Access Compliance Report

Public Rights-of-Way

(Curb Ramps)

Intersection ID: 26100	Main Street: FAIRCHILD_LN	Cross Street: HOLLY_HILL_FARM_RD	Location: SW
ADA ID: F2F9DB3128DD	Ramp Type: PerpDiag	Initial Pass/Fail: Fail	Overall Compliance: No
Codes/Mitigation Info/Possible Solution		Field Measurements/Component Compliance	
Severity Score: 13.75

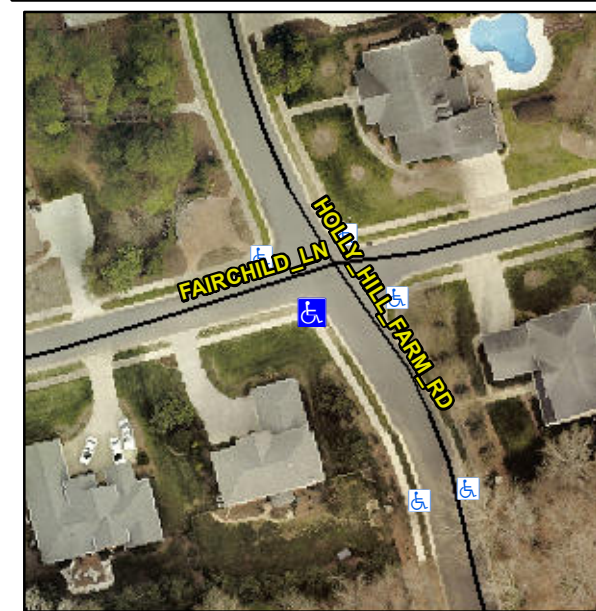
R304.2.2, R304.5.3

Compliance	Description	Data	Compliance	Description	Data
N/A	Ramp Length (in)	49.0	No	Ramp Slope (%)	8.6
Yes	Ramp Width (in)	48.0	No	Ramp XSlope (%)	3.7
N/A	Flare Type LT	N/A	N/A	Flare Type RT	N/A
N/A	Flare Slope LT (%)	N/A	N/A	Flare Slope RT (%)	N/A
N/A	Flare Traversable LT?	N/A	N/A	Flare Traversable RT?	N/A
N/A	Landing Length (in)	N/A	N/A	DWS Provided?	N/A
N/A	Landing Width (in)	N/A	N/A	DWS Contrast?	N/A
N/A	Landing Slope (%)	N/A	N/A	DWS Length (in)	N/A
N/A	Landing X Slope (%)	N/A	N/A	DWS Full Width?	N/A
N/A	Landing Curb? (Y/N)	N/A	N/A	DWS Offset (in)	N/A
N/A	Shared Landing?	N/A			
N/A	Gutter Ponding?	N/A	N/A	Gutter Slope (%)	N/A
N/A	Gutter Lip Ht (in)	N/A	N/A	Gutter X Slope (%)	N/A
N/A	Painted X Walk1?	No	N/A	Painted X Walk2?	No
	X Walk 1 Direction	To E		X Walk 2 Direction	To NW
N/A	X Walk 1 Width (in)	N/A	N/A	X Walk 2 Width (in)	N/A
	X Walk 1 Slope (%)	4.5		X Walk 2 Slope (%)	0.5
	X Walk 1 X Slope (%)	1.0		X Walk 2 X Slope (%)	3.5

Remove & Replace Curb Ramp With Two New Directional Ramps or Equivalent.
